EYNESHAM PARISH COUNCIL

Application No.	R3.0151/21
Proposal	<ul style="list-style-type: none">• The dualling of approximately 3.2km of the A40 carriageway from the existing Hill Farm junction at Witney to the Eynsham Park and Ride site (R3.0057/19) including the construction of two new roundabouts.• An eastbound and westbound bus lane approximately 6.5km in length from the Eynsham Park and Ride site to existing structures at Duke's Cut waterway (Duke's Cut Canal Bridge, Earl's Culvert, Wolvercote Railway Bridge and Wolvercote Canal Bridge);• Capacity and connectivity improvements over the existing structures at Duke's Cut waterway to enable the proposed eastbound bus lane to extend over the existing structures up to the A34 flyover in the east, forming a connection into Oxford North (Northern Gateway) strategic development site;• Construction of a new signalised junction to the Eynsham Park and Ride site;• New pedestrian/cyclist underpass at Cuckoo Lane ('the Eynsham Underpass').• Two new pedestrian/cycle bridges at Cassington Halt (Cassington Halt Footbridge North and Cassington Halt Footbridge South);• Widening of Cassington New Bridge;• Demolition and replacement/extension of e

Figure 1 – Land Use and Accessibility Baseline page 62 of Chapter 13 Population & Human Health Environmental Statement. Shows Public Rights of Way (Bridleways - pink. Footpaths - brown)

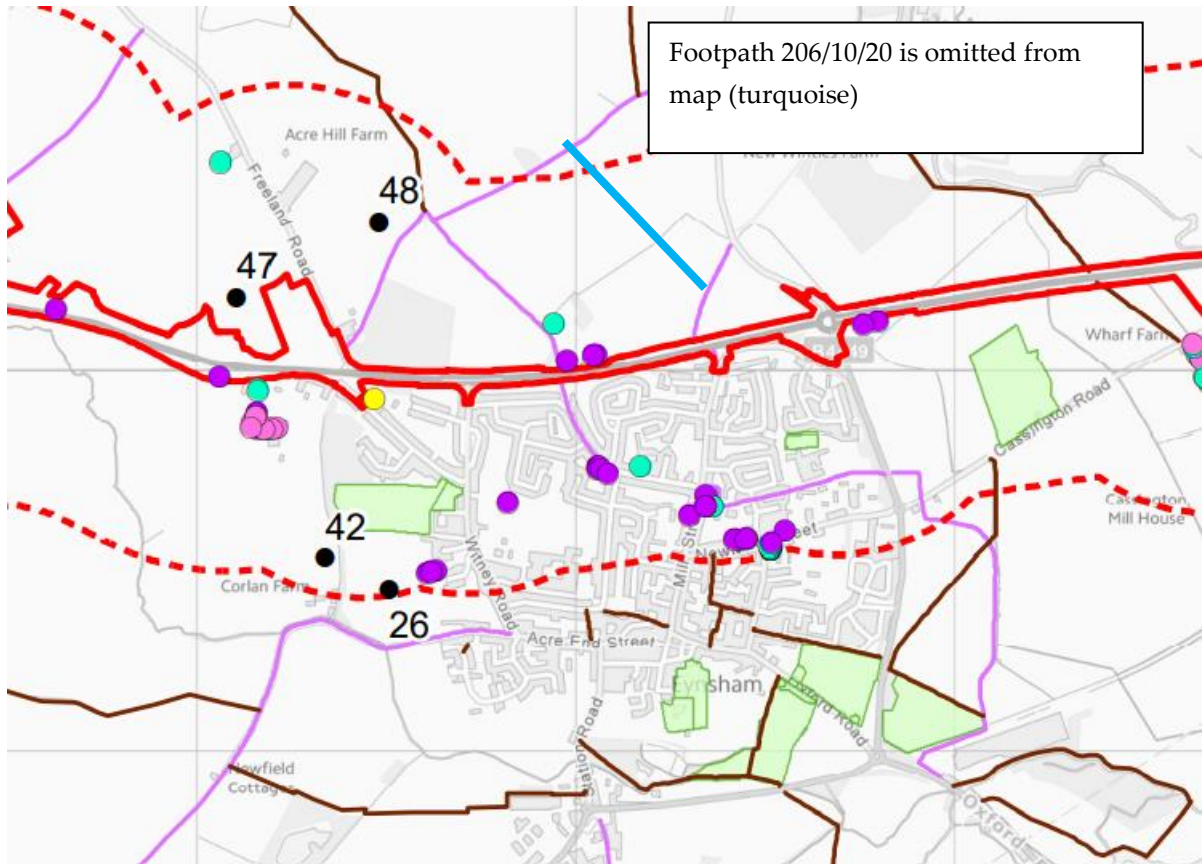
2.1 ‘Land Use and Accessibility Baseline’ map at page 62 does not include or consider PROW 206/10/20 which is shown below in turquoise. Access to the countryside and green spaces in Eynsham is very limited² and to note those north of the A40 will be closed for any length of time, is a significant concern to the community and will be strongly opposed. The recently uploaded ‘[Updated Chapter 17 Residual Effects and Mitigation](#)’ document highlights the extent of planned exclusion from the countryside being imposed on the community.

Figure 2 – Proposed Attenuation Basin adjacent to the B4449 in Flood Zone 2.

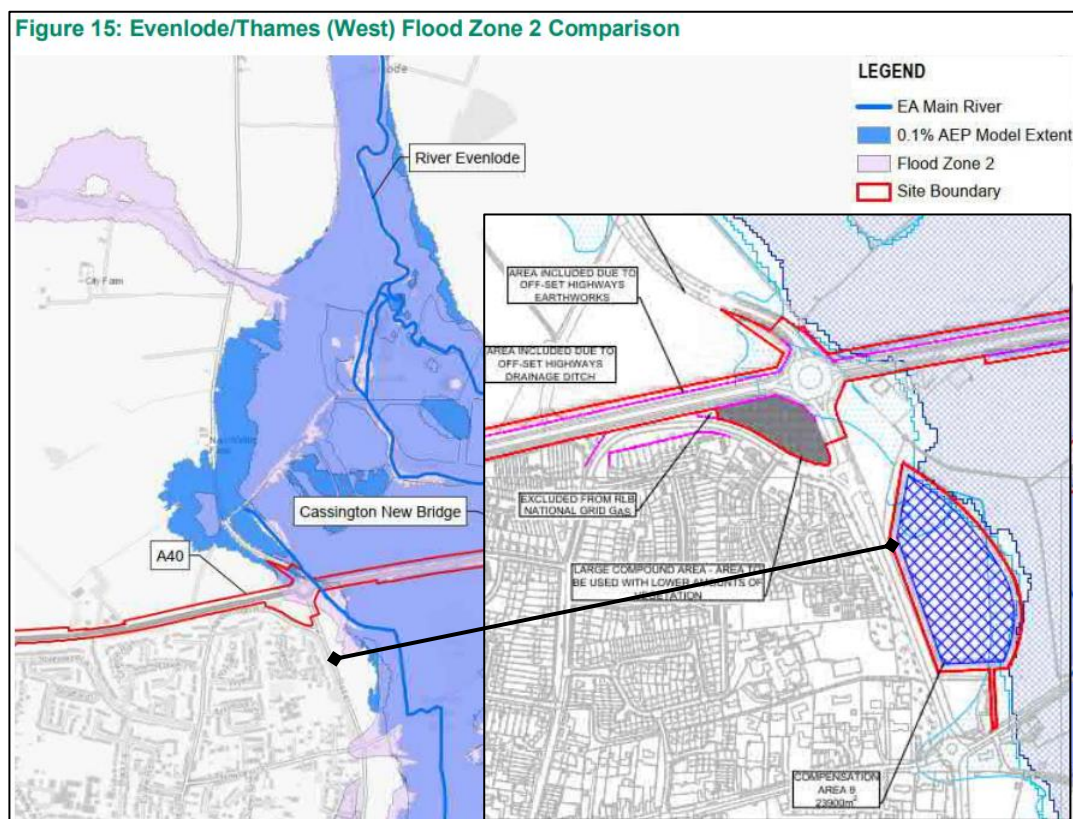
4.1 In consideration of risks associated with this location, the Council considers it negligent in so far as the Attenuation Basin could become an 'attractive nuisance' whereby children could be drawn to the location. The proposed location is close to homes and the primary school yet not sufficiently overlooked by properties that might allow some informal oversight. There are no details as to how the Attenuation Basin will be made safe to address the risk of misadventure or public health concerns.

- 4.2 We note from Figure 15 (below) detailed in the [A40 ES Vol II Appendix 14-B Final Part1%20\(1\).pdf](#) that the area to the east of the B4449 is in Flood Zone 2 with the 'main river' running within the area. However, at 14.6.4 of Chapter 14 of the [Environmental Statement](#) it states "the following design assumptions have been applied: Attenuation basins should not be located in and fluvial or pluvial flood⁷ risk areas." Note also that the soil here is clay (page 93 of Chapter 14 refers). It is therefore not understood why it is proposed to have an Attenuation Basin at this location or what the associated level of flood risk for road users or nearby residents is. The Council recommend that unless these risks are sufficiently low, this Attenuation Basin is re-designed out of the application.
